Access Compliance Report

Public Rights-of-Way

(Curb Ramps)

Intersection ID: 31686	Main Street: GALLISON_AV	Cross Street: SNOWDROP_DR	Location: S
ADA ID: 7C0A773AFA2A	Ramp Type: PerpDiag	Initial Pass/Fail: Fail	Overall Compliance: No
		Severity Score: 10

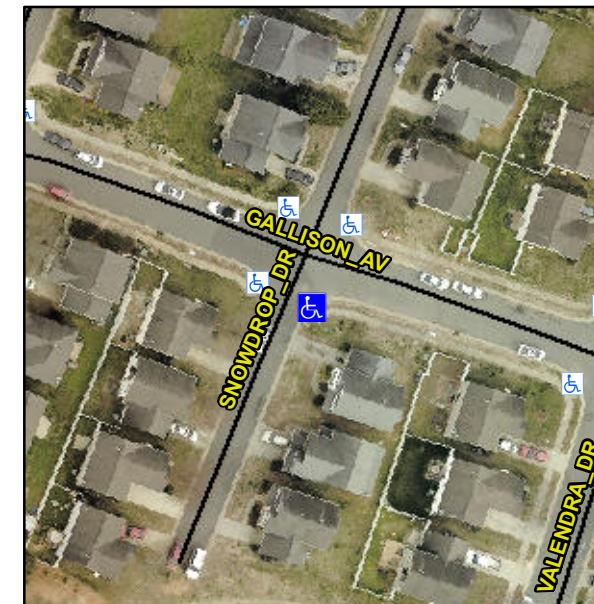
R304.5.1, R304.5.3

Compliance	Description	Data	Compliance	Description	Data
N/A	Ramp Length (in)	49.0	Yes	Ramp Slope (%)	6.4
No	Ramp Width (in)	41.0	No	Ramp XSlope (%)	3.6
N/A	Flare Type LT	N/A	N/A	Flare Type RT	N/A
N/A	Flare Slope LT (%)	N/A	N/A	Flare Slope RT (%)	N/A
N/A	Flare Traversable LT?	N/A	N/A	Flare Traversable RT?	N/A
N/A	Landing Length (in)	N/A	N/A	DWS Provided?	N/A
N/A	Landing Width (in)	N/A	N/A	DWS Contrast?	N/A
N/A	Landing Slope (%)	N/A	N/A	DWS Length (in)	N/A
N/A	Landing X Slope (%)	N/A	N/A	DWS Full Width?	N/A
N/A	Landing Curb? (Y/N)	N/A	N/A	DWS Offset (in)	N/A
N/A	Shared Landing?	N/A			
N/A	Gutter Ponding?	N/A	N/A	Gutter Slope (%)	N/A
N/A	Gutter Lip Ht (in)	N/A	N/A	Gutter X Slope (%)	N/A
N/A	Painted X Walk1?	No	N/A	Painted X Walk2?	No
	X Walk 1 Direction	To NE		X Walk 2 Direction	To NW
N/A	X Walk 1 Width (in)	N/A	N/A	X Walk 2 Width (in)	N/A
	X Walk 1 Slope (%)	3.2		X Walk 2 Slope (%)	0.8
	X Walk 1 X Slope (%)	1.0		X Walk 2 X Slope (%)	3.6

Remove & Replace Curb Ramp With Two New Directional Ramps or Equivalent.
